ADDENDUM NO. 1 to
Jordan Valley Water Conservation District
3145 West 11400 South Pump Station Improvements
Project # 4373
May 20, 2026

JORDAN VALLEY WATER
 CONSERVANCY DISTRICT
 3145 WEST 11400 SOUTH PUMP STATION
 IMPROVEMENTS

Jacobs
 INSTRUMENTATION AND CONTROLS
P&ID

VERIFY SCALE	BAR IS ONE INCH ON ORIGINAL DRAWING.
DATE	APRIL 2026
PROJ	W7Y49600
DWG	IC-1
SHEET	13 of 17

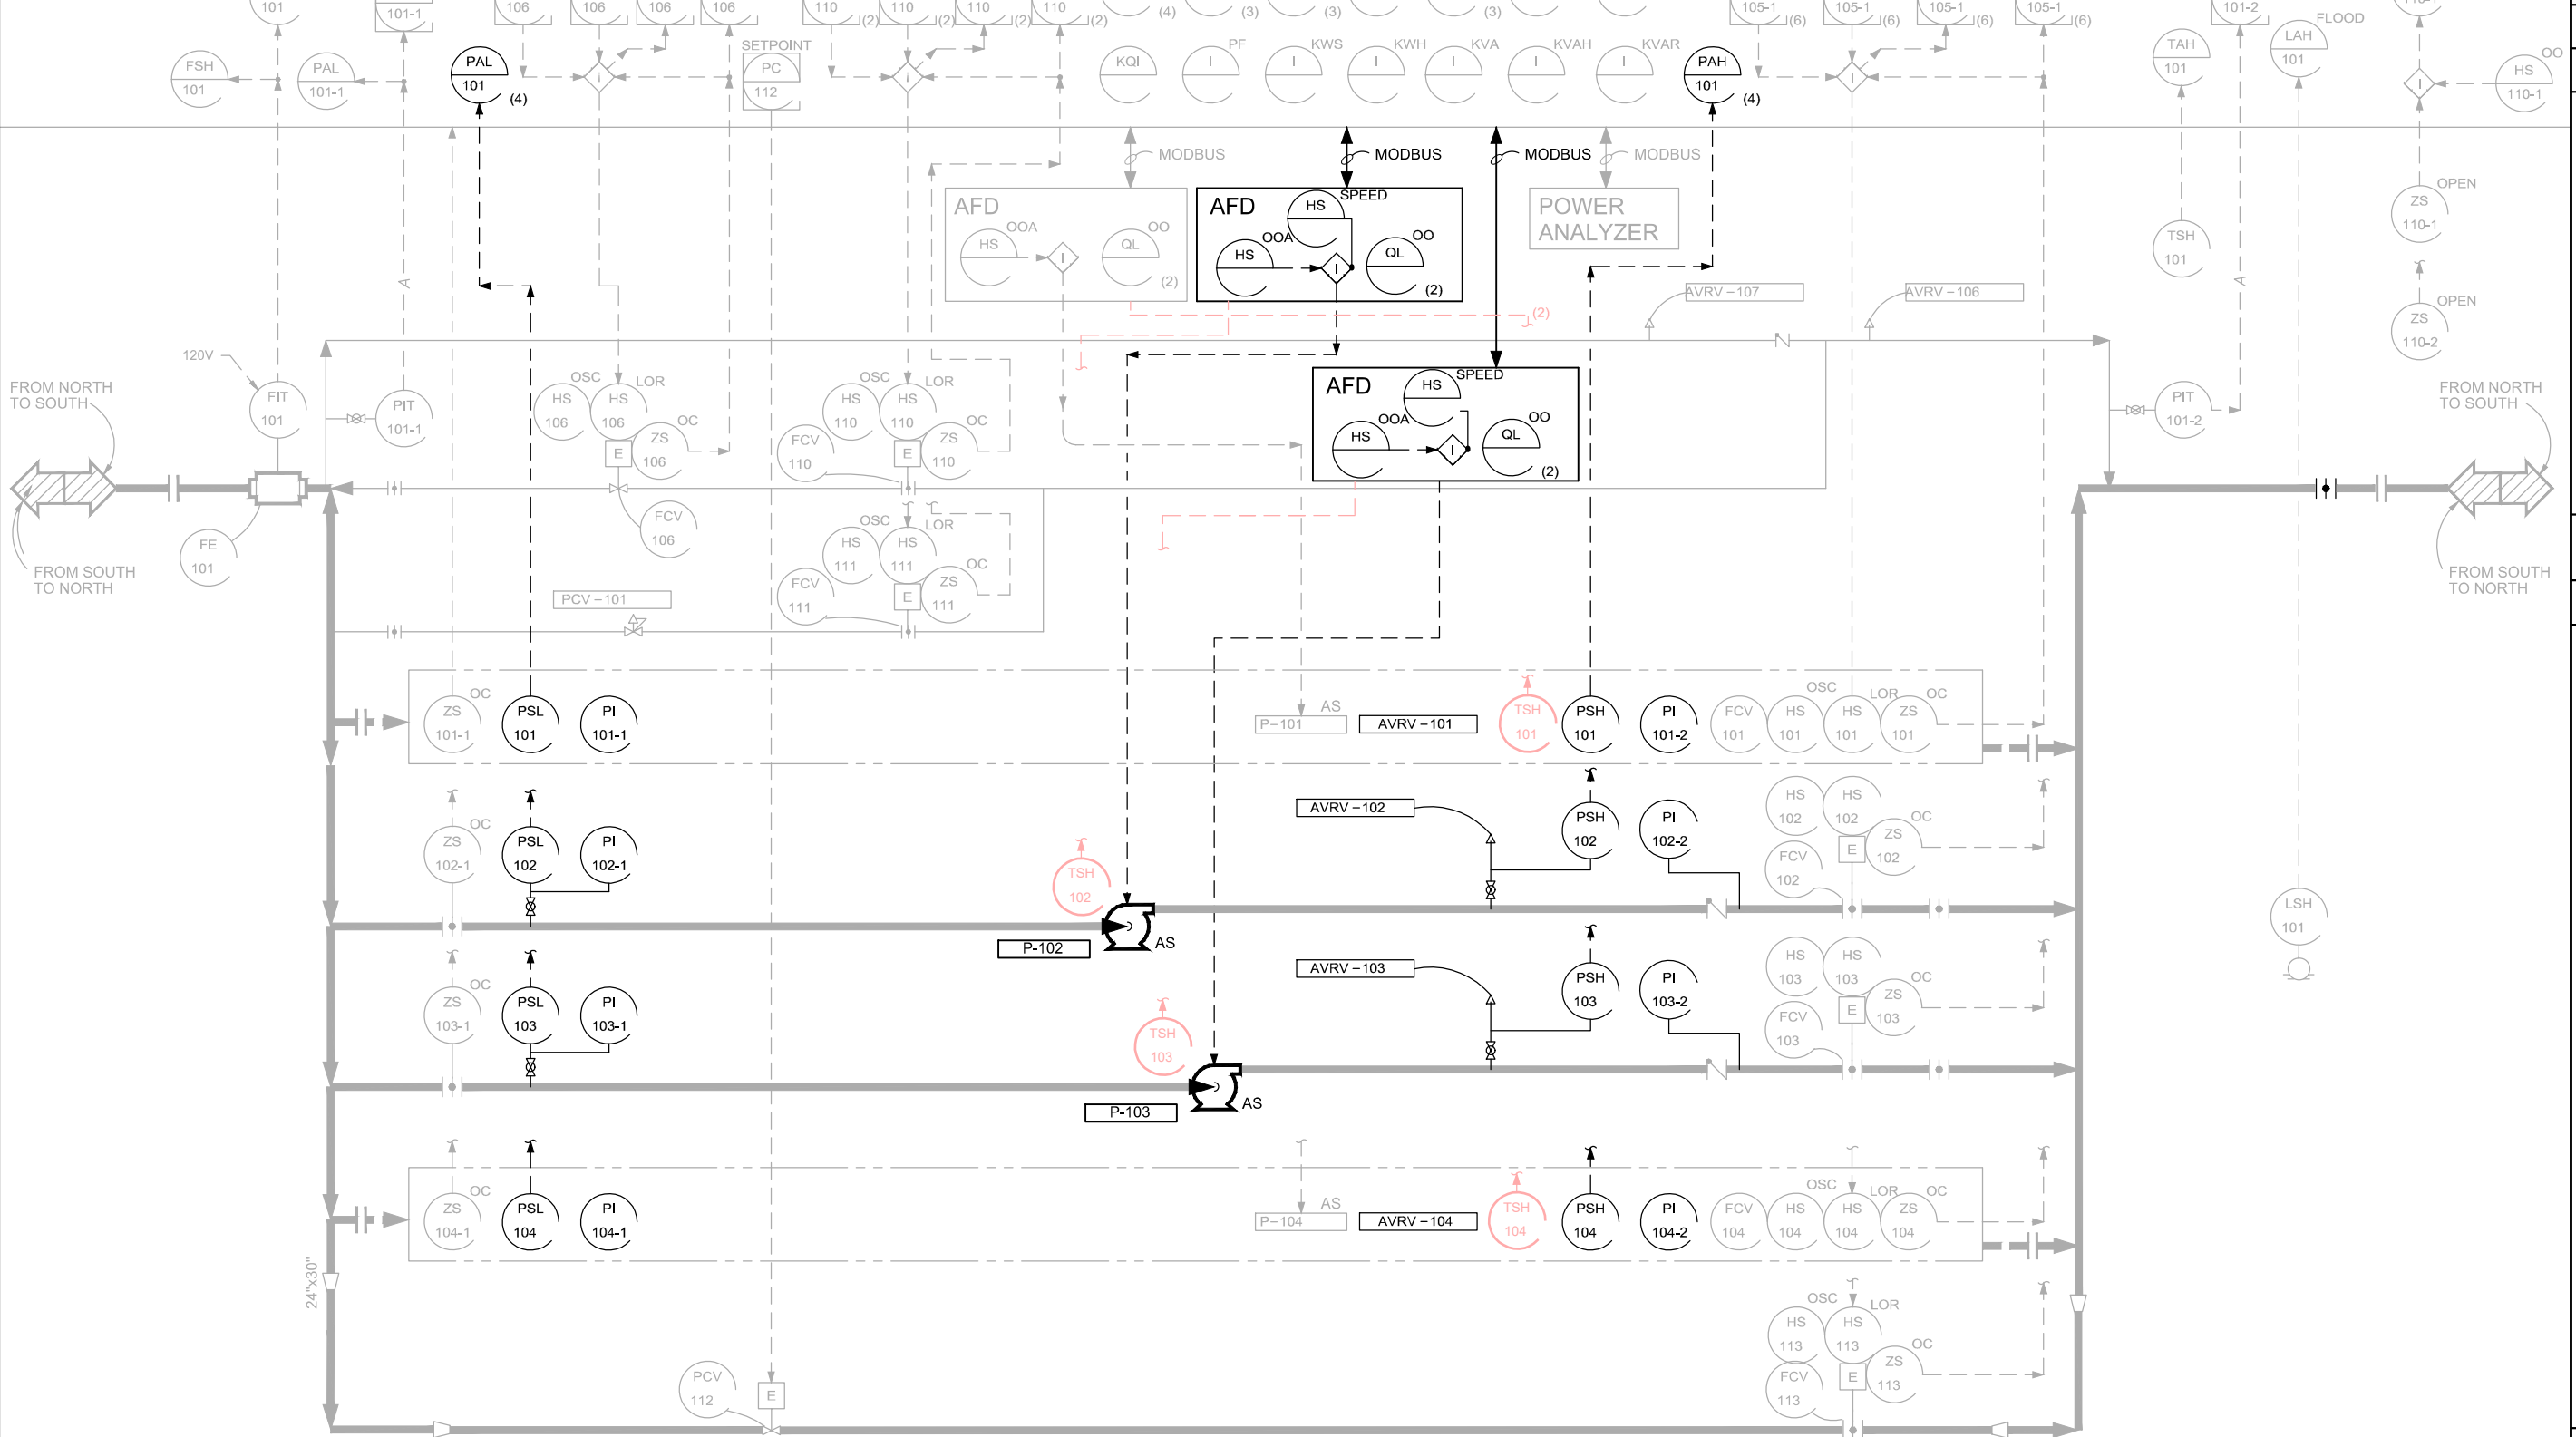
4. Drawing E-1 Note 3. REPLACE “450 KCMIL” with “350 KCMIL”.
5. Drawing E-3. Update drawing with redline markups as shown in attachment.
6. Drawing IC-1. Update drawing with redline markups as shown in attachment.
7. Drawing SD-4, Detail 4090-692, Combination Air Vane Callout. REPLACE “VEN-O-MAT, RBX SERIES OR APPROVED EQUAL” with “VEN-O-MAT, RBX SERIES 050-RBxB-25-21-S4 WITH THREADED T-OUTLET”.
